# ENGINEERING NOTICE

E.N. NO. 82268-C  
PAGE 1 OF 3  
ISSUE DATE 9-4-74

MODEL NUMBER <b>620-30</b>	EFFECTIVE SERIAL <b>EARLIEST</b>	PARTS DISPOSITION	
DEVICE <b>9 TRK MAG</b>	<b>OPPORTUNITY</b>	<input checked="" type="checkbox"/> USE AS IS	<input type="checkbox"/> SCRAP
TAPE CONTR. <b>BD 1 &amp; 2</b>		<input type="checkbox"/> REWORK	<input type="checkbox"/> NOT APPLICABLE

TITLE  
9 TRACK RAW  
25 IPS  
MAG TAPE OPTION

Build the following assy. and mount in position M4 of board #2. Label assy.  
01A1231-002.

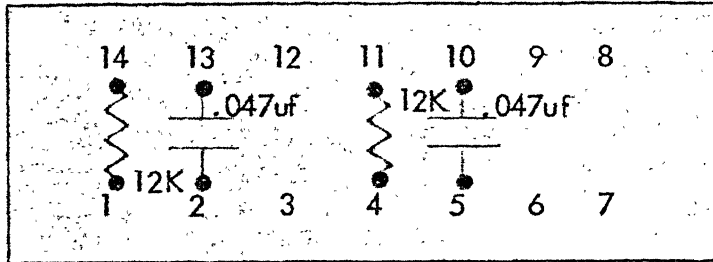
### 3.2.2

WIRE TO MTU CABLE W/L #75 WD662  
 LABEL DIA 1231-002

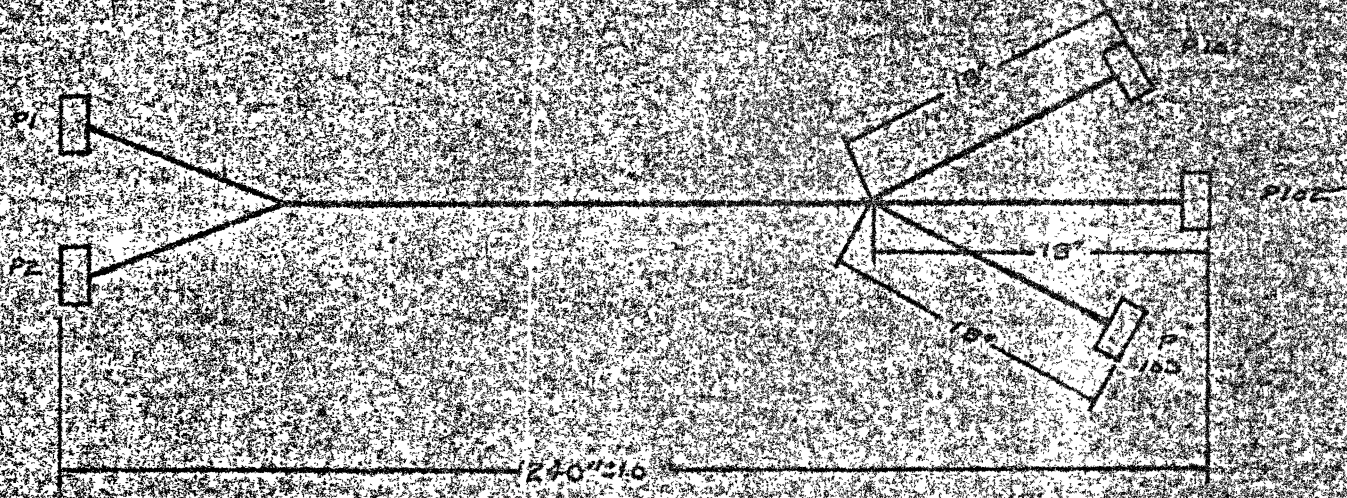
Use cable 01A1231-002 described in this document page 15.
